**Coal Combustion Waste Impoundment
Task 3- Dam Assessment Report**

John E. Amos Plant (Site 26)

*Bottom Ash Dam
American Electric Power
St. Albans, West Virginia*

**Project # 0-381
Assessment of Dam Safety
Coal Combustion Surface Impoundments
For the REAC Program**

Figure 5.3.1-1. Low Inlet Overflow Outlet Structure at the North Corner of the Treatment basin.

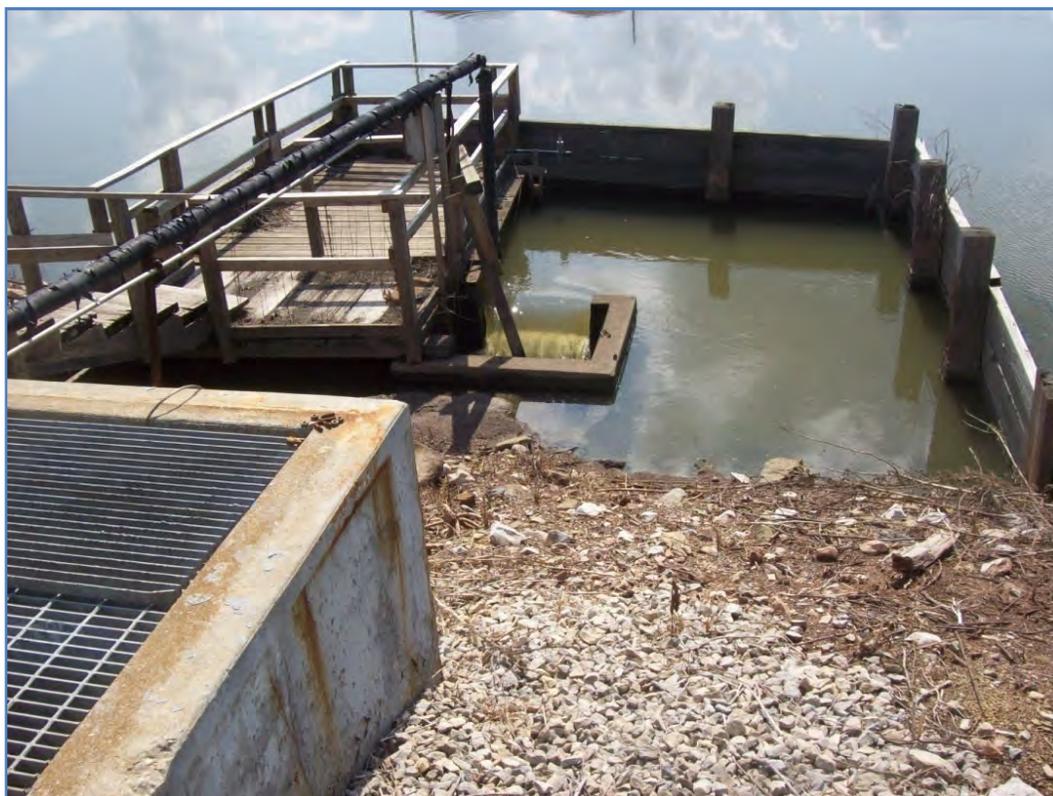
Currently there are two principal spillway outlets, one with a low inlet and one with a high inlet. The low inlet is an overflow structure with inlet crest elevation of 576.1 ft and a discharge capacity of 28.2 cfs which is the reservoir drain capacity. This drop inlet structure consists of a square concrete box approximately 36 inches on each side with an approximately 24 inches long weir on the west side. The outlet pipe is a 24 inch corrugated metal pipe which takes the water from the Treatment Basin to the outfall at Kanawha River. The primary overflow structure was observed to be working properly, discharging flow from the pond, and visually appeared to be in satisfactory condition. There was no sign of clogging of the spillway and the water exiting the outlet was flowing clear. Figure 5.3.1-1 shows the low inlet overflow structure.

Figure 9.2.1-1- John Amos Bottom Ash Pond Piezometer and Boring Locations for the Dam Modification Study.

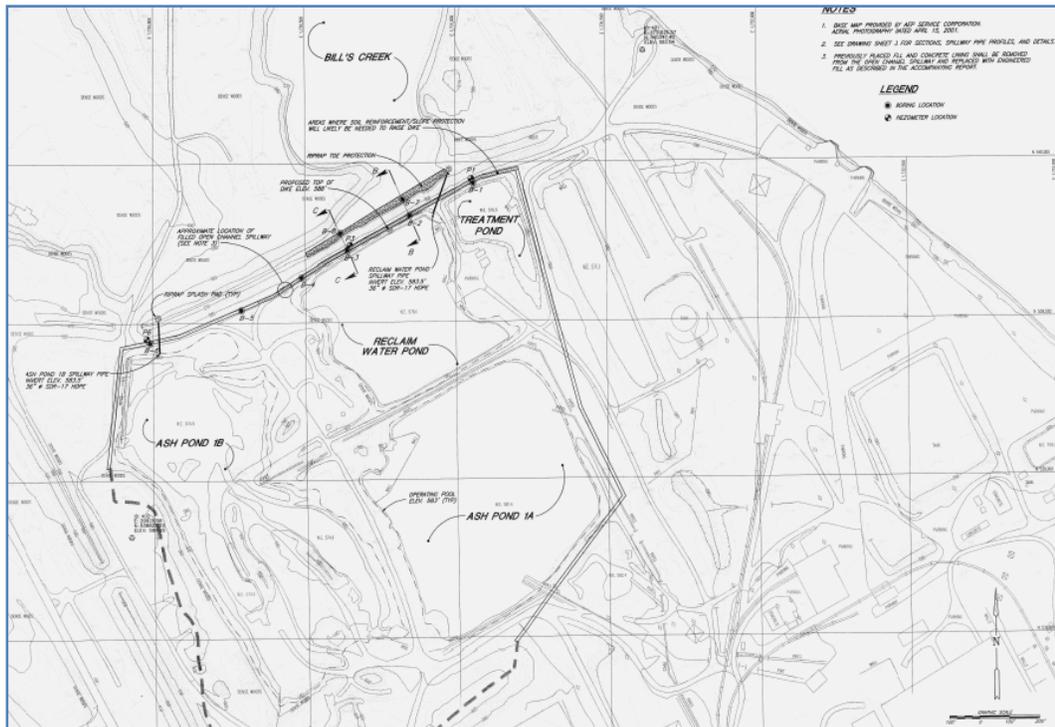
There are no indications that any dam instrumentations were in use prior to the studies for the proposed dam modification in 2005. However, in conjunction with the proposed modifications to the embankments three piezometers were installed and readings were taken since 2005 (see Appendix A- Doc 08). Also, eight borings were drilled through the main dike in August 2005 and the observations from these boring logs were analyzed. This information may be useful in any future studies related to the embankment safety of the dam.

There was no instrumentation plan provided. Figure 9.2.1-1 shows the location of the piezometers and the borings used for the dam modification study (image from Appendix A- Doc 04).

Instrumentation monitoring program is inadequate. The data reviewed does not show that adequate instrumentation for displacement or seismicity has been implemented for this dam.
